DEVELOPMENT APPLICATION ASSESSMENT REPORT

Application Number:	DA2025/0308
----------------------------	-------------

Responsible Officer:	Tess Johansson
Land to be developed (Address):	Lot 85 DP 30836, 39 Arnott Crescent WARRIEWOOD NSW 2102
Proposed Development:	Alterations and additions to a dwelling house including a swimming pool
Zoning:	R2 Low Density Residential
Development Permissible:	Yes
Existing Use Rights:	No
Consent Authority:	Northern Beaches Council
Land and Environment Court Action:	No
Applicant:	Matt Thitchener

- The proposed awning over a existing deck lies outside the building envelope. Building envelope encroachment of 0.9m to 0.5m for a length of 5.6m. refer to figure 1. Figure1. West building envelope

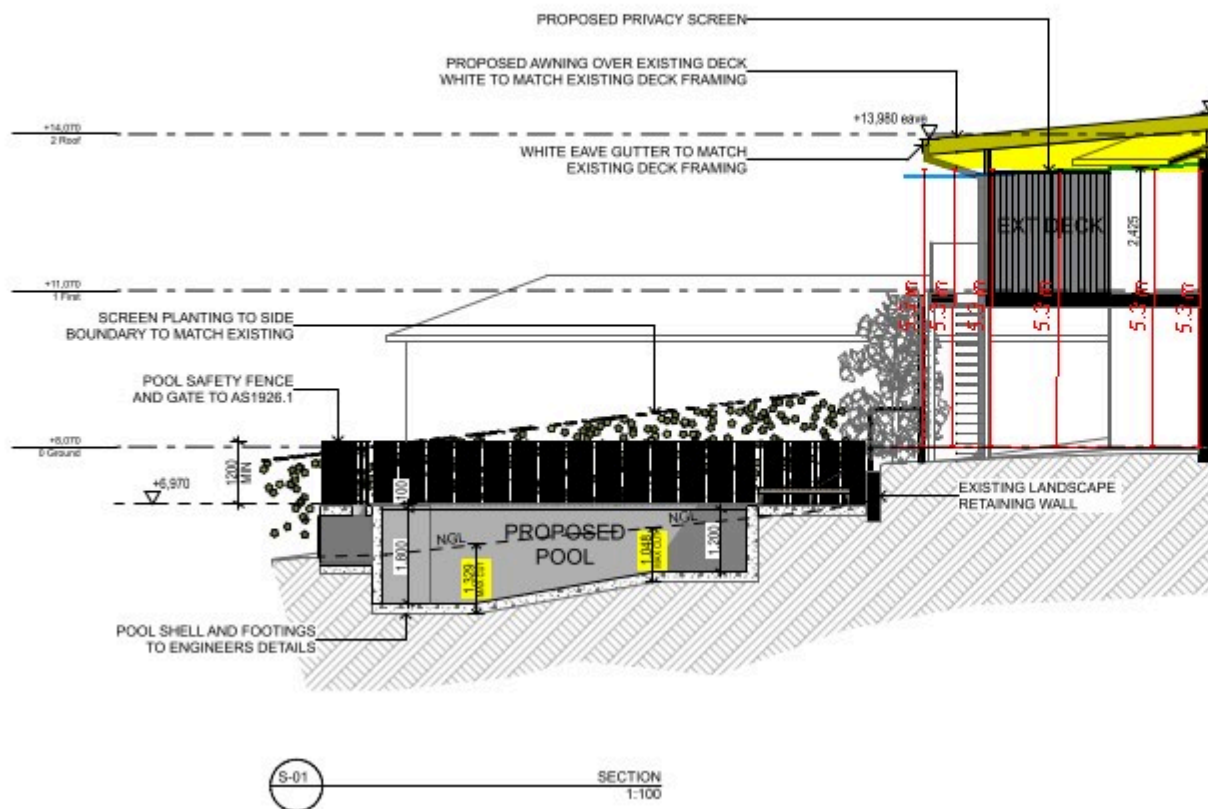
The awning is located over an existing rear facing deck. As it is a simple roofed, lightweight structure that extends over the balcony, the extent of breach of the building envelope is inappreciable and does not impact upon any adjoining property, be it overshadowing, bulk or scale or views. As such the breaches are considered acceptable.
